Delegated Report

Householder Planning Application

Planning Application No: 20240905

Description: Erection of a two storey side extension.

45 degree test

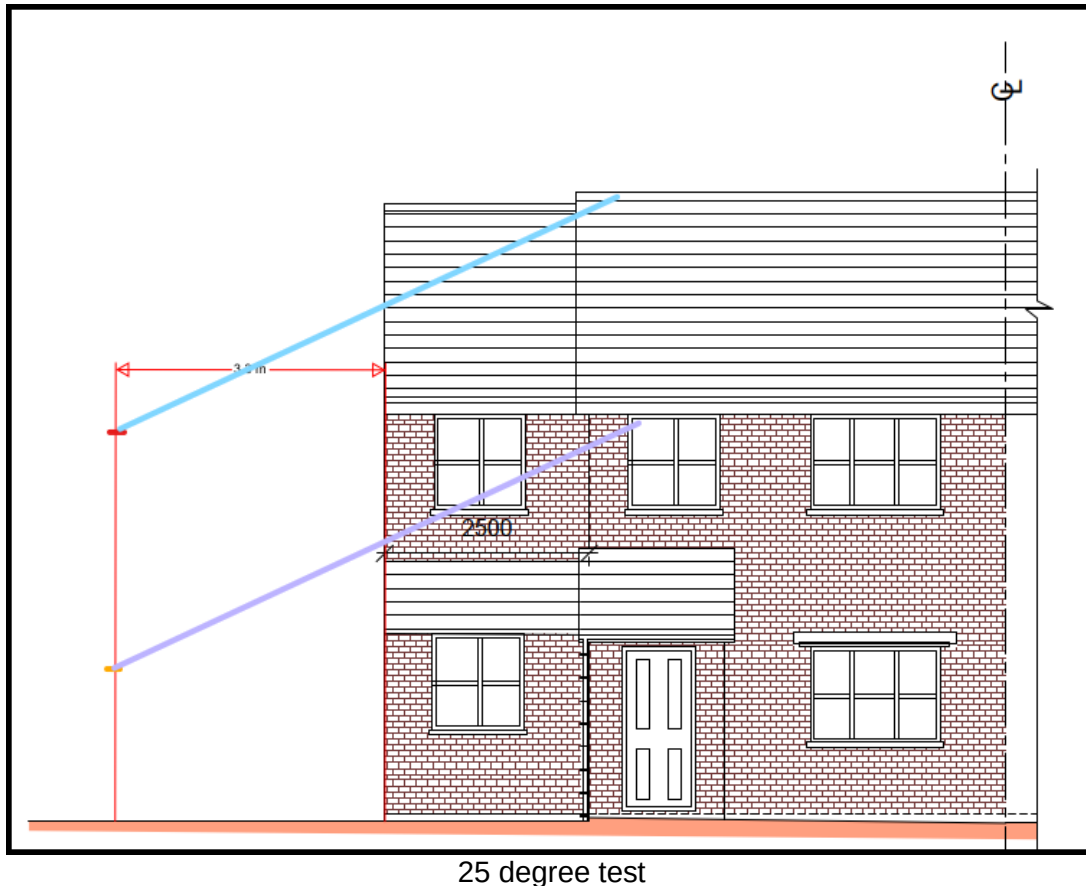
The below 45- and 25-degree tests shows the approximate positions of the windows, taking into account the slightly higher ground level of no.19. The tests show the potential of the proposed extension to overshadow these windows.

As the above tests show, there is potential for overshadowing to the bathroom and kitchen.

The changes in design therefore would **NOT** overcome refusal reason 2.

The proposal is therefore **NOT** considered to safeguard the amenity of neighbouring properties in compliance with policy CS19 of the Core Strategy 2014 as it would result in overshadowing of the neighbouring properties windows.

Figure 1

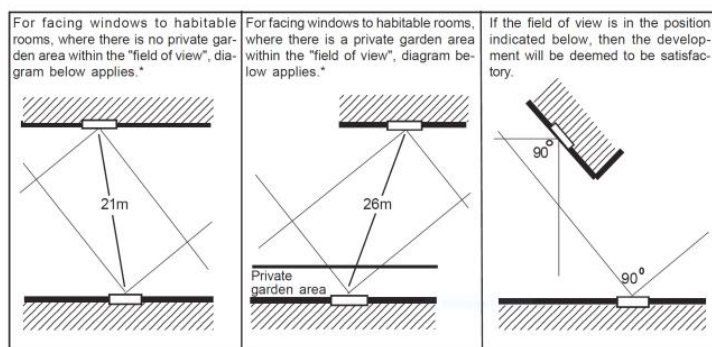
No windows are proposed to the side elevation and so no direct overlooking would occur to neighbouring property no.19. The neighbours across the road would have additional front facing windows, facing their property. These neighbours are 21.6m from the subject dwellinghouse and so the new windows would comply with the minimum 21m privacy distance applied by the Residential Layout Guidelines (2006) and as detailed in the figure below.
